# UNITED STATES PATENT AND TRADEMARK OFFICE

APPLICATION NO.	FILING DATE	FIRST NAMED INVENTOR	ATTORNEY DOCKET NO.	CONFIRMATION NO.
10/565,267	01/20/2006	Andrey B. Prozumenshchikov	074-486-0013	7106
20277 7590 09/17/2008 MCDERMOTT WILL & EMERY LLP 600 13TH STREET, N.W. WASHINGTON, DC 20005-3096				
EXAMINER TUCKER, DANIEL P				
ART UNIT		PAPER NUMBER		
4159				
MAIL DATE		DELIVERY MODE		
09/17/2008		PAPER

**Office Action Summary****Application No.**

**DETAILED ACTION**

Fig. 2 of Thomson

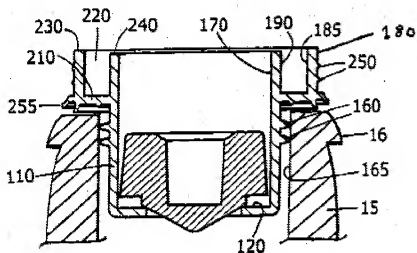
4. In re Claim 1, with reference to Fig. 1, Fig. 2, Fig. 3 and Fig. 5 of Thomson above, Thomson discloses:

- a discharge sleeve (10) with outer (20) and inner pipes (30) at its inlet end, a collar (portion A) with an external thread (300), raking props (95) and a plug (90) at its outlet end;

- an inner hood (280) with ~~splines on its side exterior surface~~ and a pouring tube (60) at its outlet end, said inner hood being threadedly engaged on the collar (portion A) of the discharge sleeve (10) thereby to allow its axial movement resulting from rotation,

- a removable gate installed on the exterior side surface of the inner pipe, said gate having sealing lips (160) on its exterior surface and a flange (210) on its outlet end, said flange being located between the inner (30) and the outer pipes (20),

- an outer hood (330) having a tamper-indicating means (320) at its outlet end, ~~splines on its interior side surface thereby to engage splines on the inner hood, and transverse projections to interact with the inlet end of the outer pipe of the discharge sleeve,~~

- said outer pipe (20) having longitudinal ribs (100) on its interior surface,
- said plug (90) being supported by raking props (95) and used to shut off the pouring tube (60), the wall of the discharge sleeve has windows (40a-c) therein, said windows being spaced evenly around the periphery of the wall of said

discharge sleeve, and inwardly bent projections (25a-c) located under the said windows (40a-c), characterized in that the mating surfaces of the pouring tube (60) and the plug (95) are tapered, the tamper-indicating means (320) at the outlet end of the outer hood is made as a break-away member fixed on the end surface by means of at least three break-away strips (paragraph 94, lines 11-14), which are spaced evenly around the periphery of the interior surface of the end of the outer hood, or by means of a solid annular break-away strap located at the interior surface of the end of the outer hood, and the valve member (130) is made of a material which ensures its tight abutment to the seat of the removable gate (paragraph 0101, lines 7-8).

Fig. 2 of US Patent No. 6,332,550 B2 (Bennett et al. hereinafter)

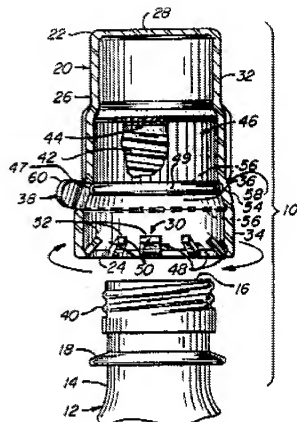
5. However, with reference to Fig. 2 and Fig. 14 of Bennett et al. above, Bennett et al. discloses transverse projections (48) on the outer hood to interact with the inlet end of the outer pipe (18). Bennett et al. also discloses splines (84e) on the outer hood that engage splines (76e) on the inner hood.

6. Thus, it would have been obvious to one of ordinary skill in the pertinent art at the time the invention was made to have modified the inner hood and the outer of the device disclosed by Thomson to have splines as taught by Bennett et al. in order to achieve the predictable result of making the hoods engage one another. It also would have been obvious to one of ordinary skill in the pertinent art at the time the invention was made to have modified the outer hood of the device disclosed by Thomson to have transverse projections as taught by Bennett et al. in order to achieve the predictable result of enabling the outer hood to interact with the inlet end of the outer pipe.

Fig. 7 of Thomson

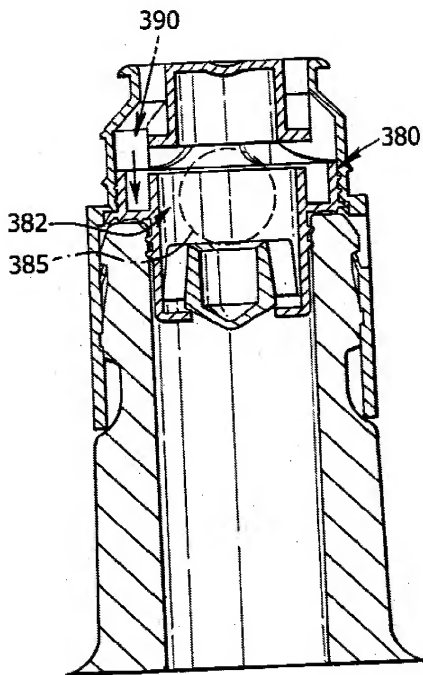
7. In re Claim 2, with reference to Fig. 7 of Thomson above, Thomson discloses that the ball (385) of the valve is made of e.g. glass, crystal, marble (paragraph 0103, line 2)
